Attachment 2

Mark-ups for the Associated COLA Revisions for 2.5.2 RAIs

2.5.2 Roadmap

Mark-up for FPL Revised Response
to NRC RAI No. 02.05.02-2 (eRAI 5896)

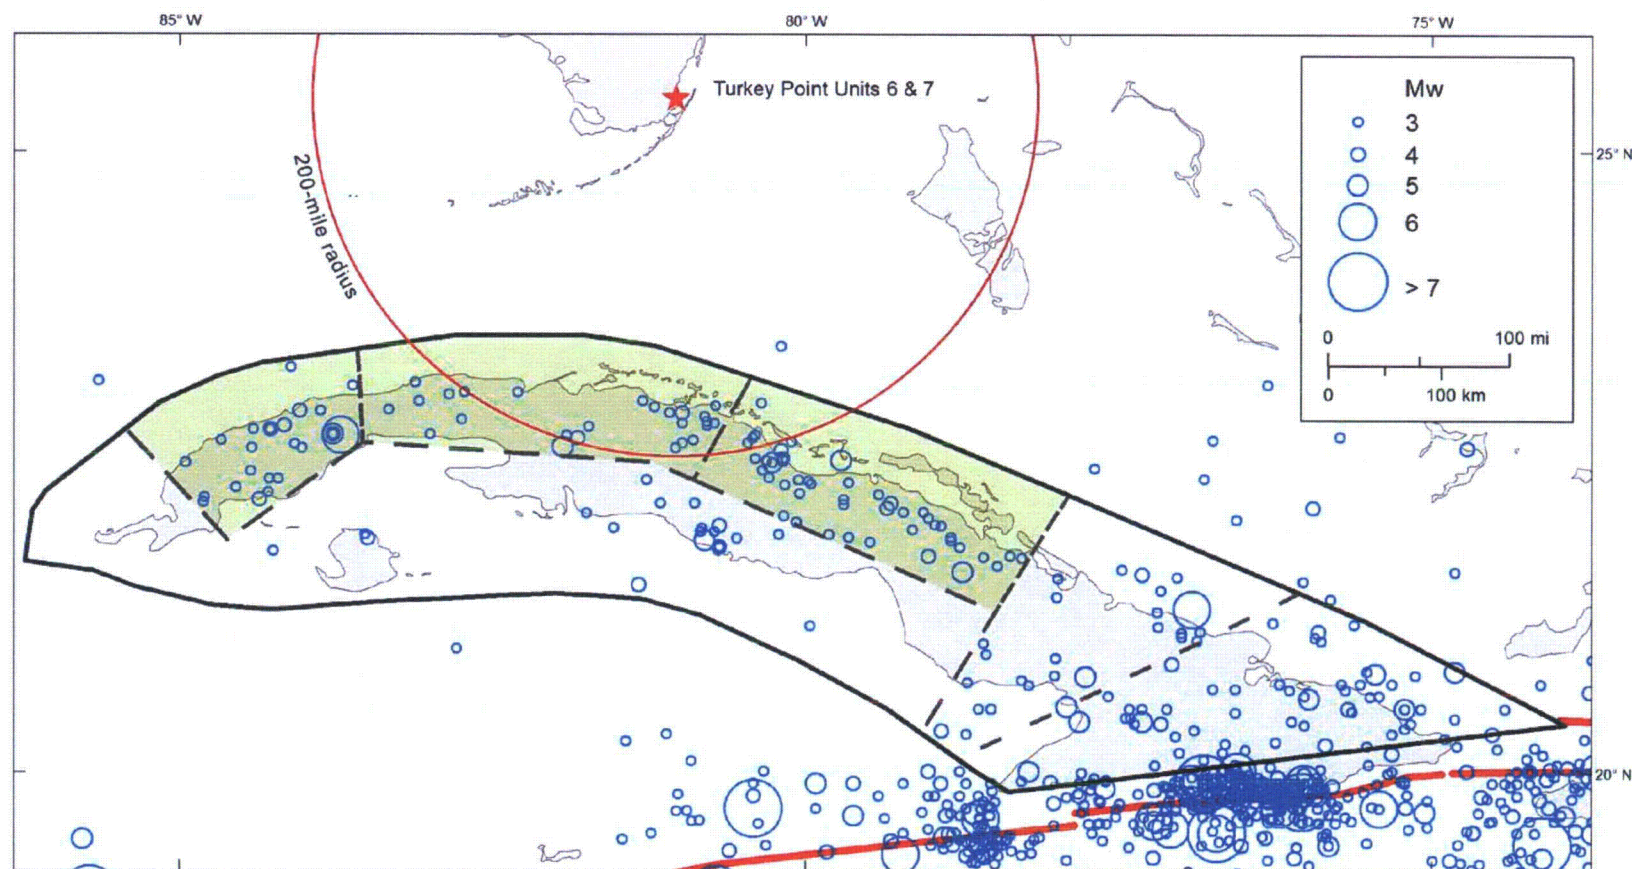
- **Six areal source zones scenario (Z6)**: In the six areal source zones scenario, Cuba is divided into six zones largely on the basis of observed patterns in seismicity (Figure 2.5.2-271). The seismicity b -value is constant across all six zones and equivalent to that used in the Z1 scenario; the seismicity a -values vary from zone to zone, are uniform within each zone, and are based on the observed seismicity within each zone. For the six-zone scenario (Z6), the a -values were determined by counting the number of events in each subzone greater than or equal to M_w 3.0. The b -value in base case Z1 is used for all six subzones. The Z6 scenario results in the lowest contribution to hazard from the three zone scenarios (Table 2.5.2-233).

Figure 2.5.2-272 Map of Intraplate Cuba Fault Sources for Hazard Sensitivity Calculation

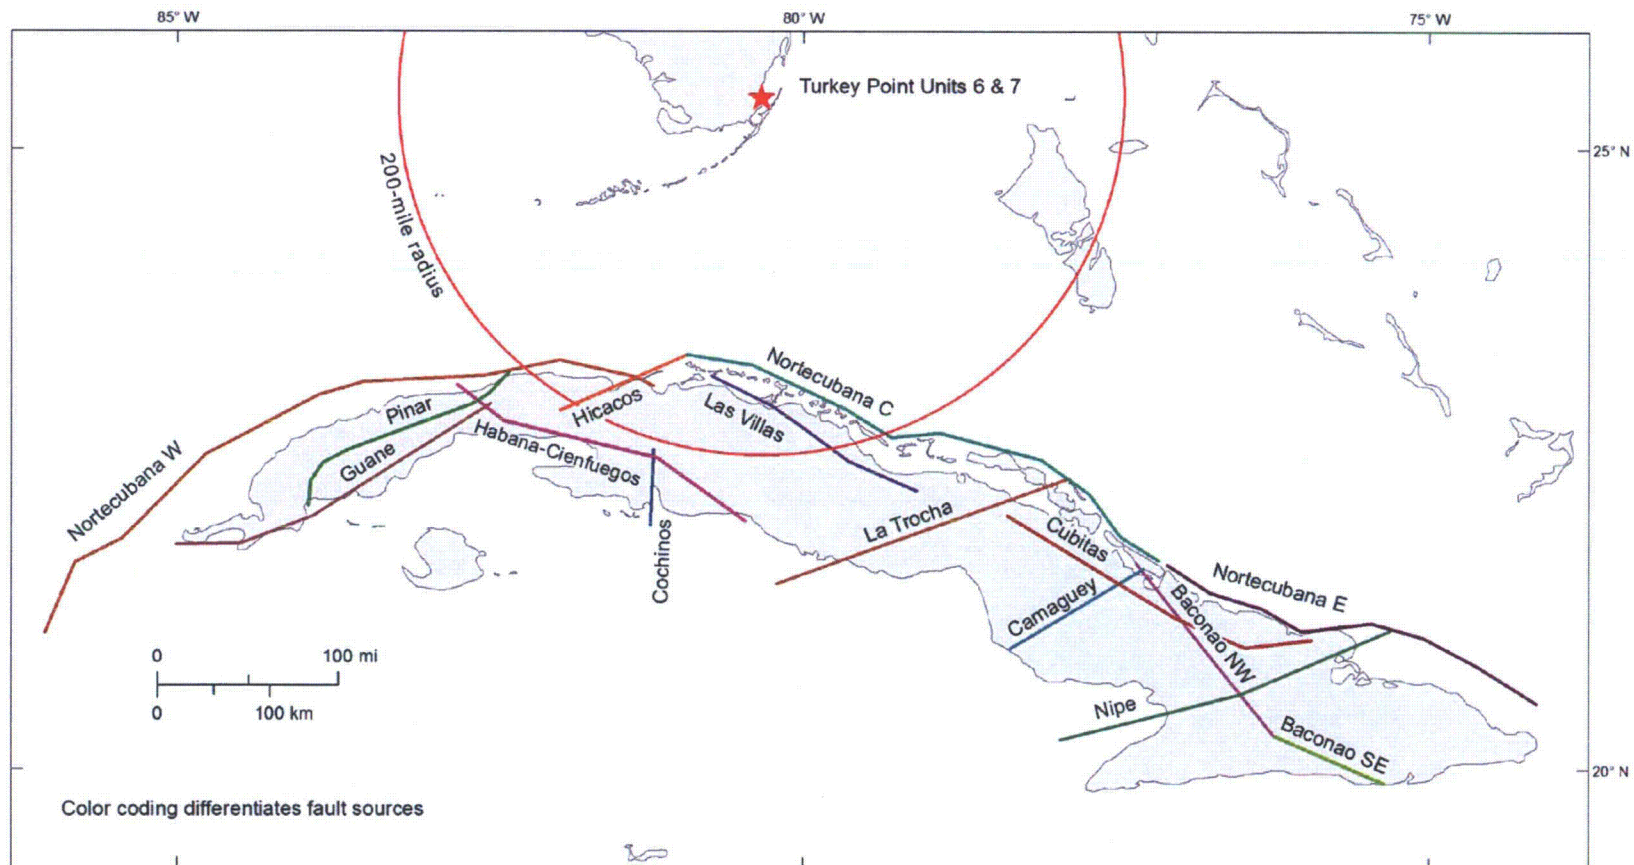
The input parameters for the Cuba sensitivity fault sources are described below and are summarized in Table 2.5.2-236 and Figure 2.5.2-272:

- **Fault sources and geometries**: Intraplate Cuba fault sources include Cotilla-Rodriguez et al.’s (Reference 321) seismoactive faults in Cuba, plus the Pinar fault (Figure 2.5.2-272). For the purpose of the hazard sensitivity calculation, it is assumed that all of these faults are capable tectonic sources. The Nortecubana fault is divided into three sensitivity fault sources, the Nortecubana West, Nortecubana Central, and Nortecubana East fault sources. The Baconao fault is divided into two sensitivity fault sources, the Baconao Northwest and the Baconao Southeast fault sources. Seismogenic depth for all fault sources in the hazard sensitivity calculation extends from 0 - 15 ~~km~~ kilometers (0-9 miles). All fault sources are modeled with vertical dip angle, except the three Nortecubana fault sources, all of which are modeled as dipping 30 degrees to the south.

Figure 2.5.2-273 1 Hz Mean Hazard Curves Showing Sensitivity to Cuba Source Scenarios. Lower Panel is Expanded View of Yellow Box in Upper Panel

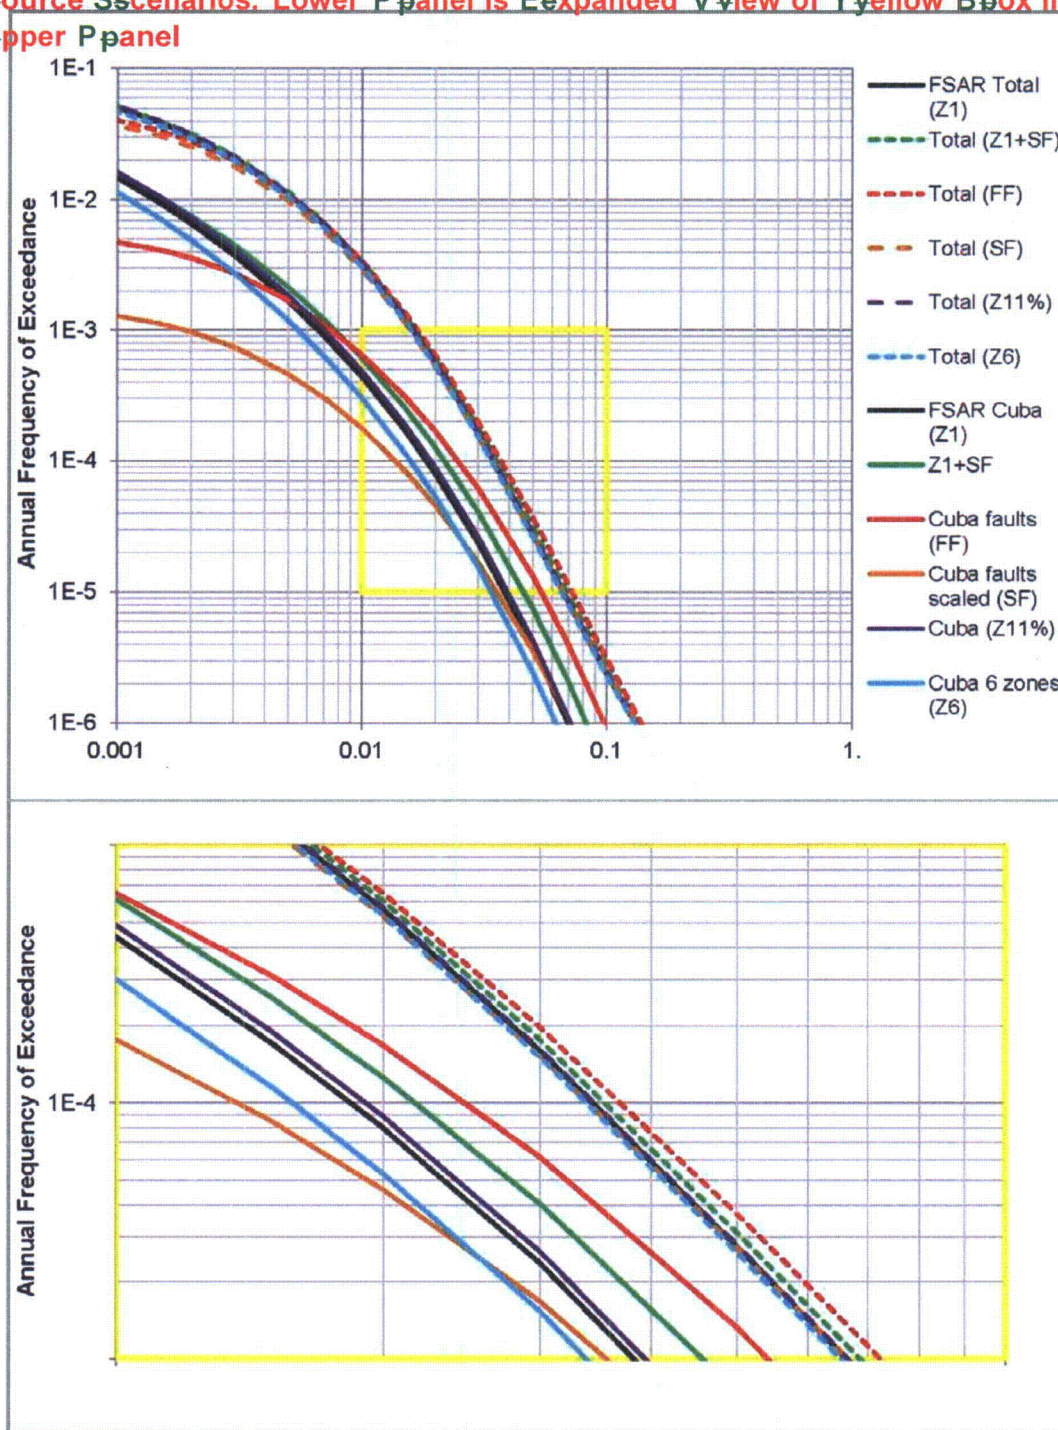
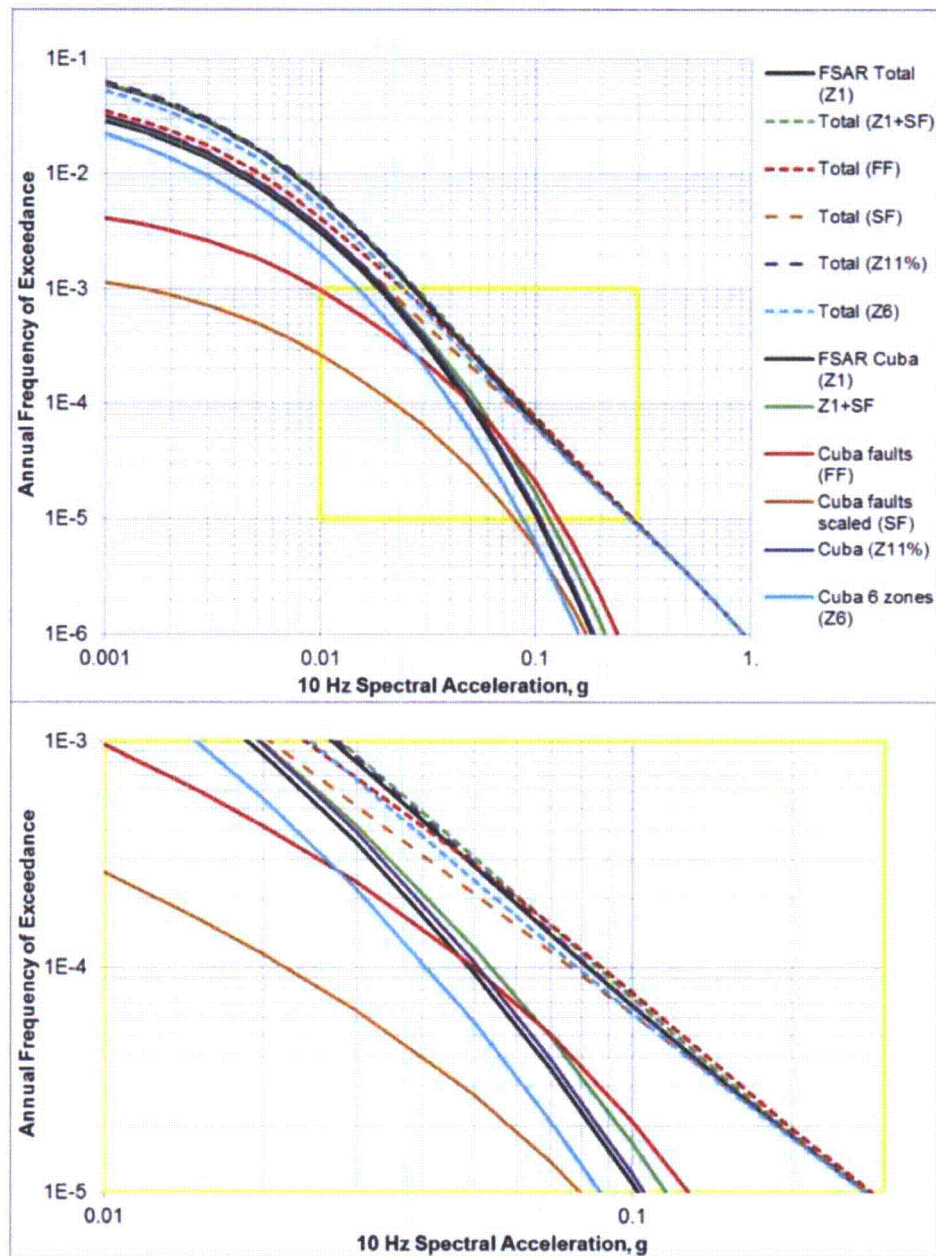
~~In order to~~To assess the impact of various Cuba sensitivity scenarios on the Turkey Point Units 6 & 7 site hazard, based on the evaluation of the hazard results presented in Figures 2.5.2-273 and 2.5.2-274, four sensitivity scenarios (Z6, Z11%, SF, and Z1+SF) were selected to represent the Cuba hazard in lieu of the Z1 base case scenario used for the original base case hazard total. Total hazard curves that include these four scenarios are presented in Figure 2.5.2-275, along with the original total hazard.

Figure 2.5.2-275 Total Mean Hazard Curves for 1 Hz (Upper) and 10 Hz (Lower) Showing Sensitivity to Four Cuba Source Scenarios

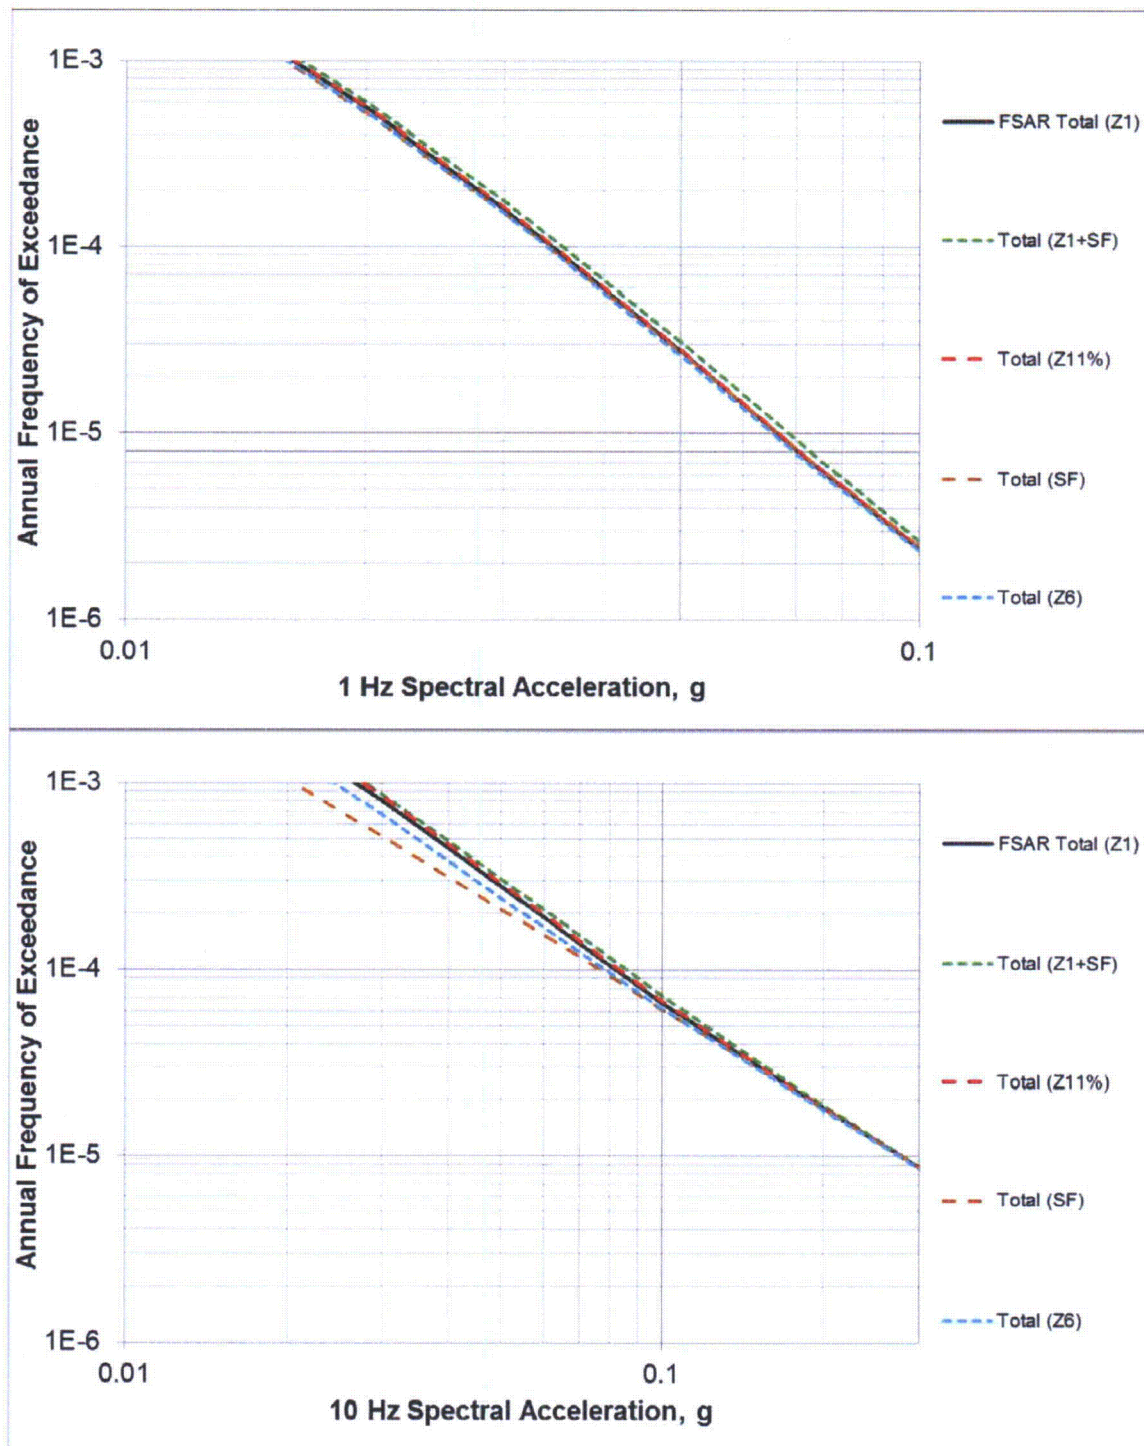
The scenarios presented in Figure 2.5.2-275 are derived from a reasonable range of technically defensible seismic source characterizations for intraplate Cuba. As shown in Table 2.5.2-239, this range of seismic source characterizations results in only small changes in hazard at the Turkey Point Units 6 & 7 site. Based on the results of these hazard sensitivity calculations, it is concluded that the use of a single areal source zone and the parameters used to characterize it as presented in Subsection 2.5.2.4.6 gives a reasonably conservative estimate of the contribution to site hazard from intraplate Cuba seismic sources.

Figure 2.5.2-276 ~~USGS National Seismic Hazard Map Earthquake Sources~~ **Seismic Sources from the U.S. Geological Survey's 2008 National Seismic Hazard Mapping Project**

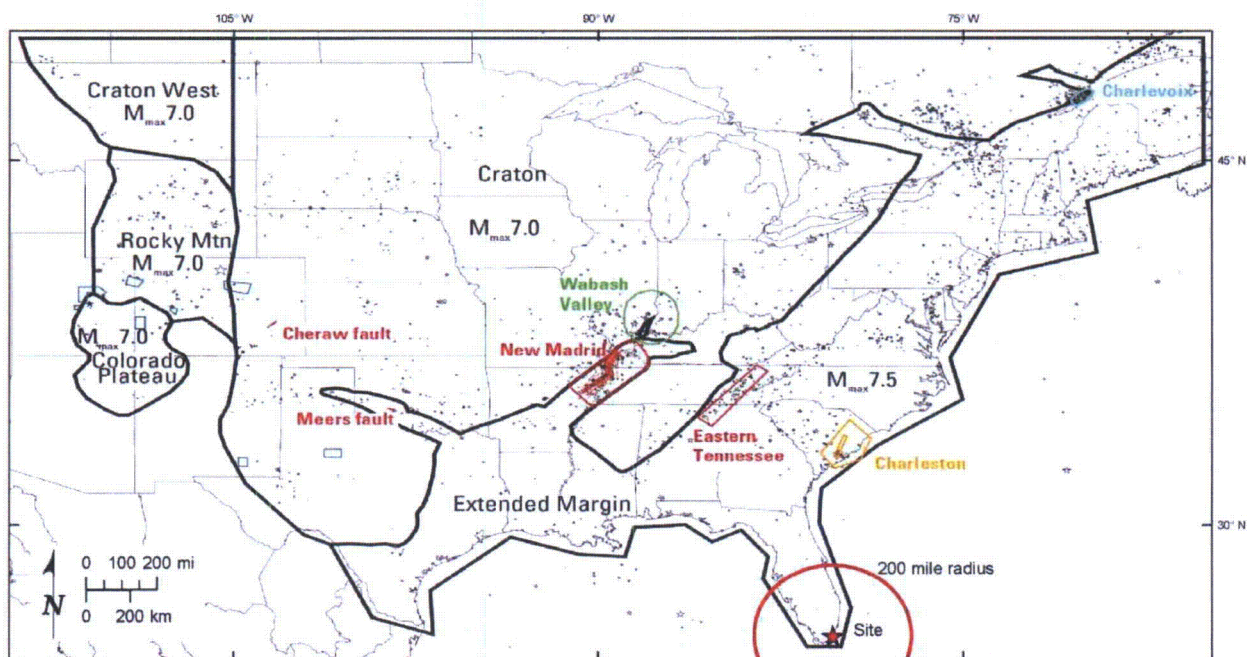
The 2008 NSHMP earthquake sources are depicted in Figure 2.5.2-~~258~~ 276. Significant changes from the 2002 NSHMP model of seismic hazard in the CEUS (Reference 251) include: (1) uncertainty in the maximum magnitude (Mmax) assigned to Mmax zones (e.g., ~~e~~Extended ~~m~~Margin); (2) revised geometry of the Charleston seismic source zones; and (3) revised magnitudes, rates, and geometry for the New Madrid seismic source. As a result of these updates, the 2008 NSHMP characterizes Mmax for the Extended Margin and Craton as weighted distributions ranging between M7.1 - 7.7 and M6.6 - 7.2, respectively. The two areal zones defining the Charleston source are both assigned Mmax distributions of M6.8 - 7.5 with a recurrence interval of 550 years, unchanged from the 2002 NSHMP. The USGS NSHMP Charleston seismic source update is discussed in ~~FSAR~~ Subsections 2.5.2.4.4.2.2 and 2.5.2.4.4.2.3.

Figure 2.5.3-205. Potential Quaternary Tectonic Structures within the Site Region

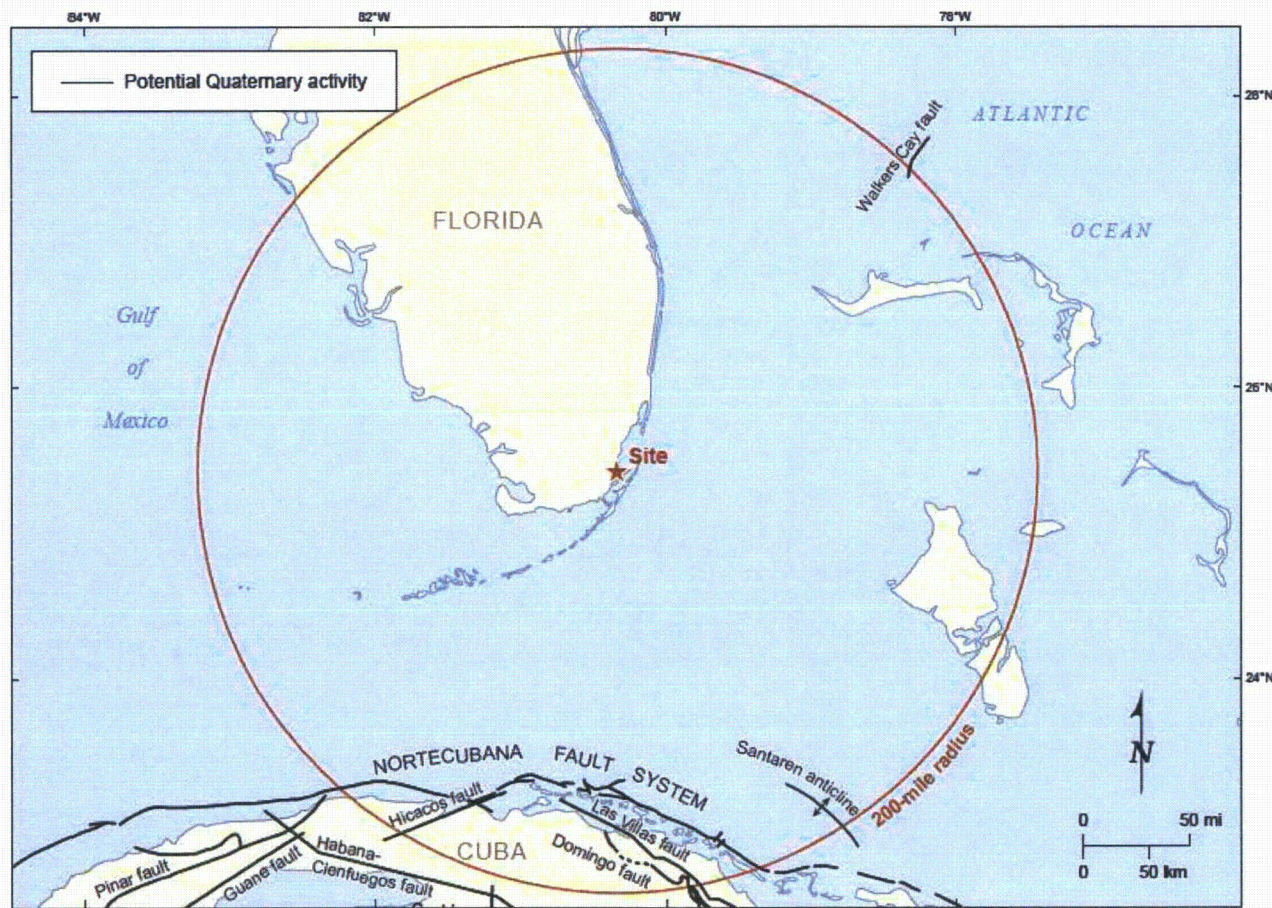
FSAR Figure 2.5.3-205 "Potential Quaternary Tectonic Structures in the Site Region" will be added to Subsection 2.5.3 in a future COLA revision as indicated below:
